**Washington County New Agricultural Museum
Phase II**

Addendum No. 1

October 6, 2011

BMGM Project # 2009 - 09

SHEET
A1.01
NUMBER

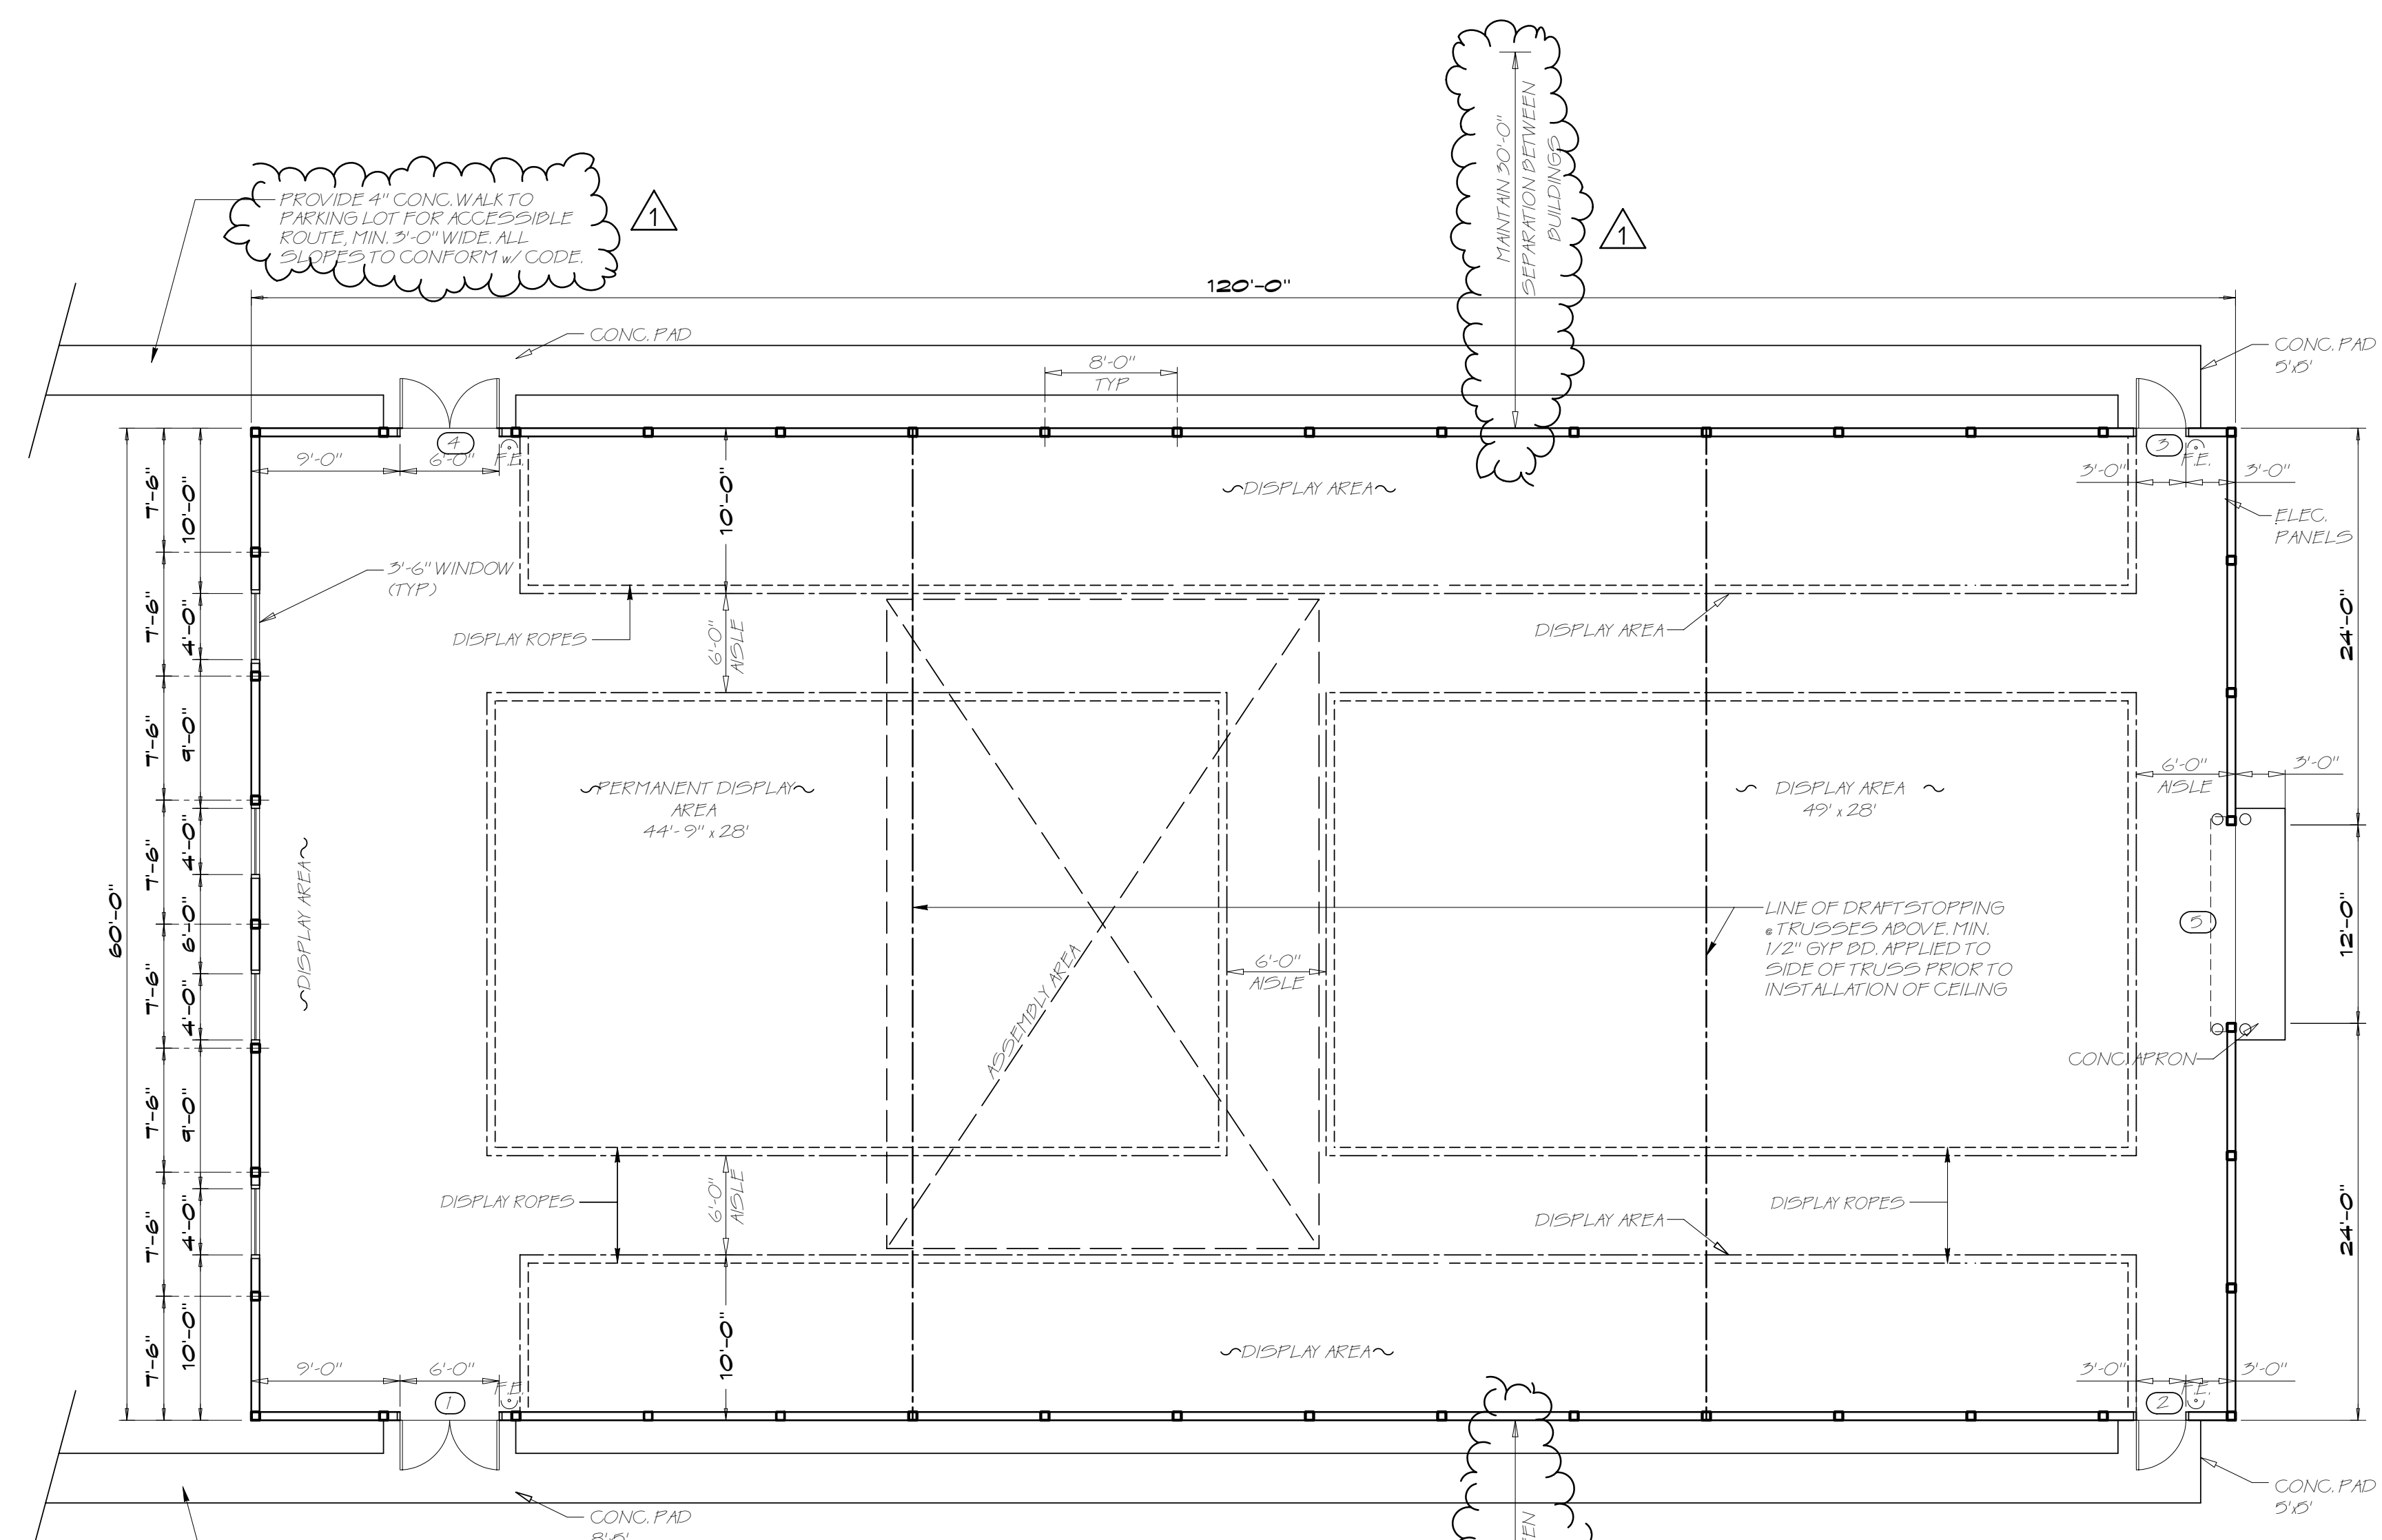
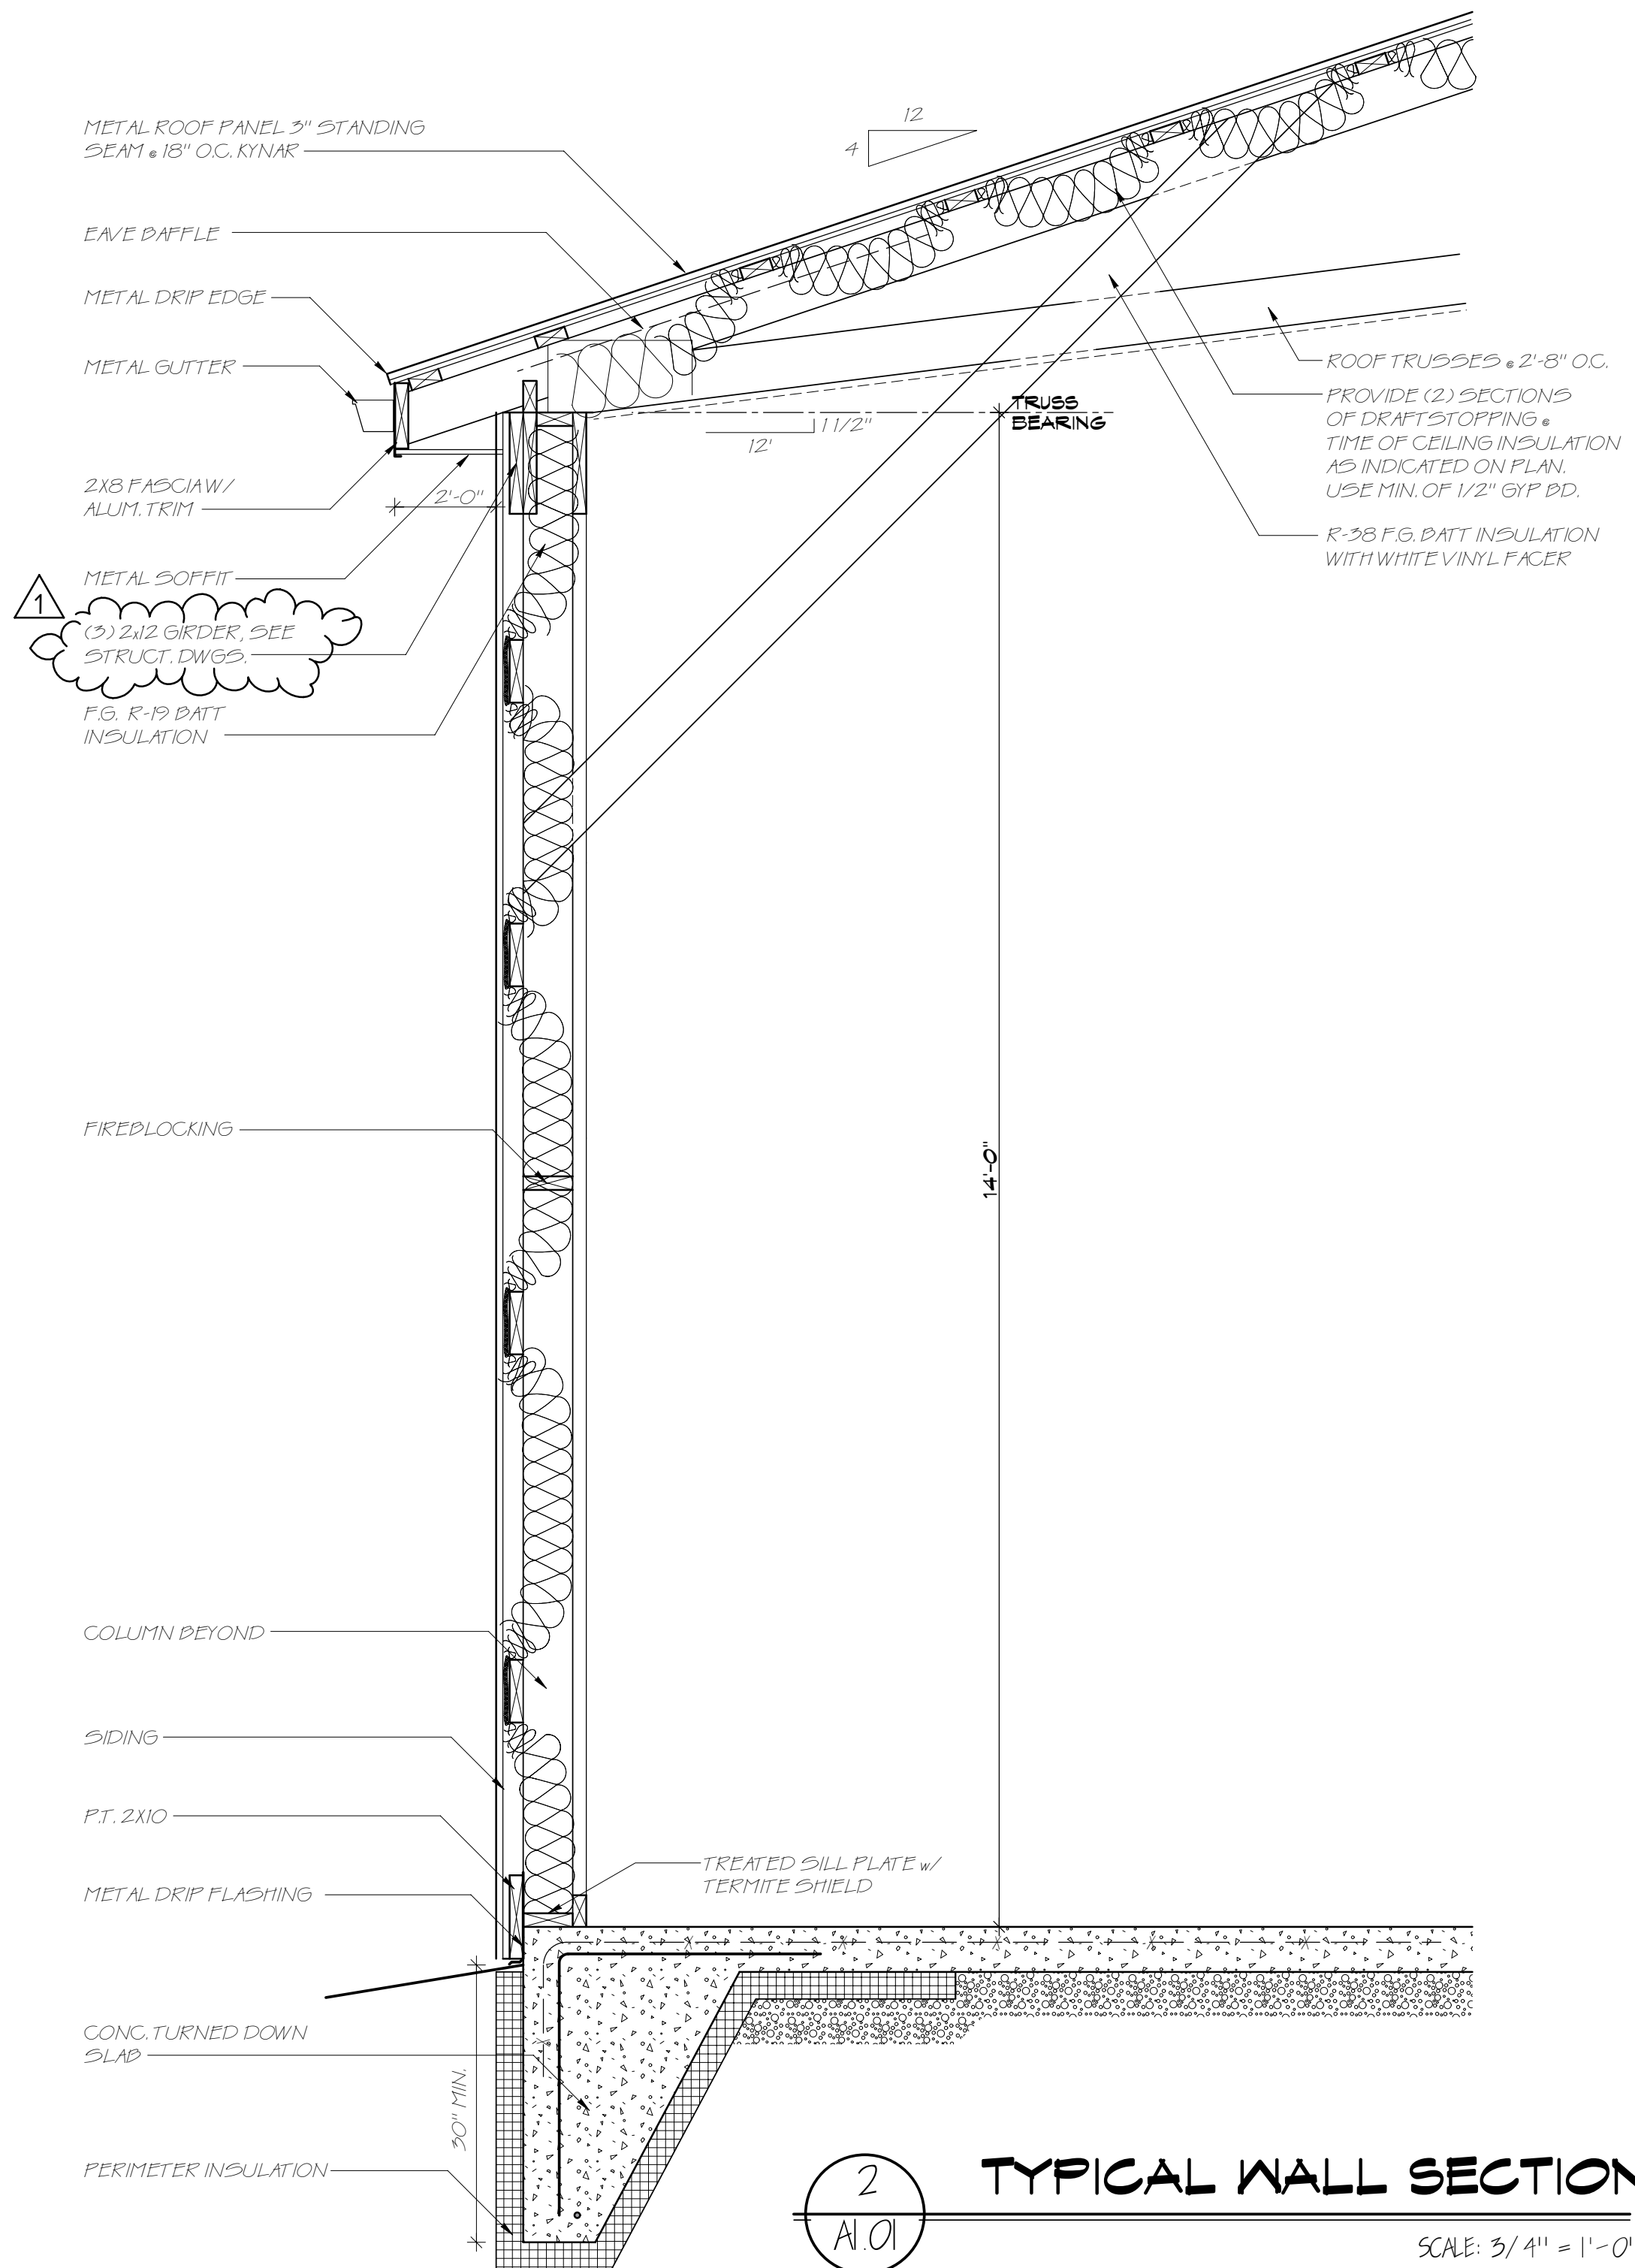
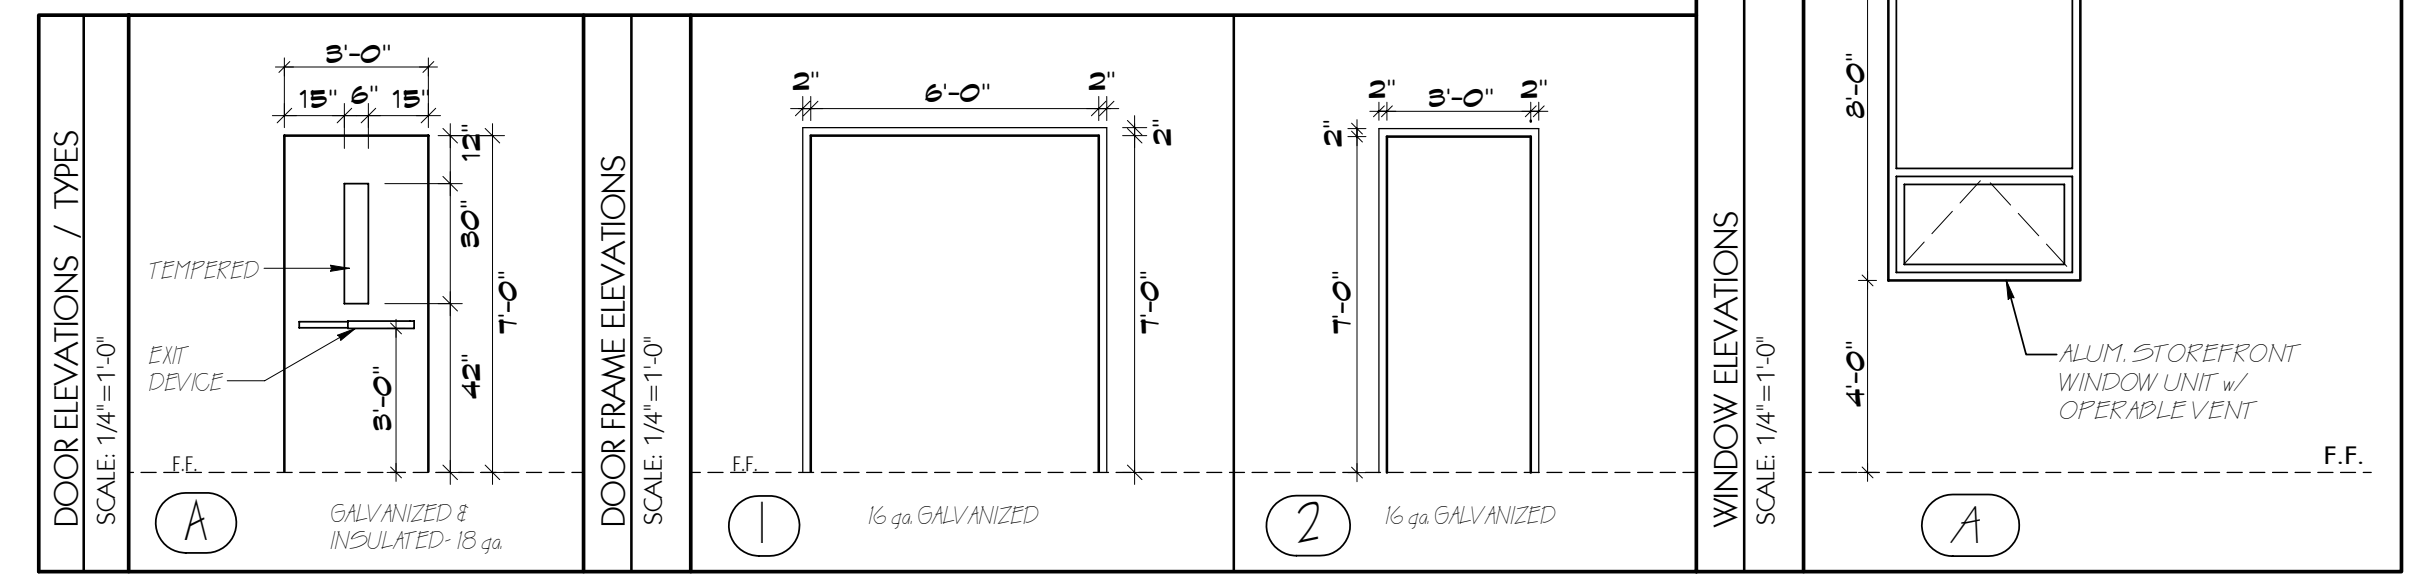
- Item 1-8 Sheet A1.01 Plan, Sections and Schedules - Delete this sheet in its entirety and insert the Revised sheet A1.01 per this addendum, dated 10/7/2011, as Attachment #2. Note the following changes: 3” standing seam roof panel, 1 1/2 per 12 slope for bottom chord of truss, truss spacing at 32” o.c., delete gypsum board on interior side of wall section, insulation to be draped over top chord truss purlins and wall girts, overhang to be noted at 2’0”, revise the window dimension to 4’0”.
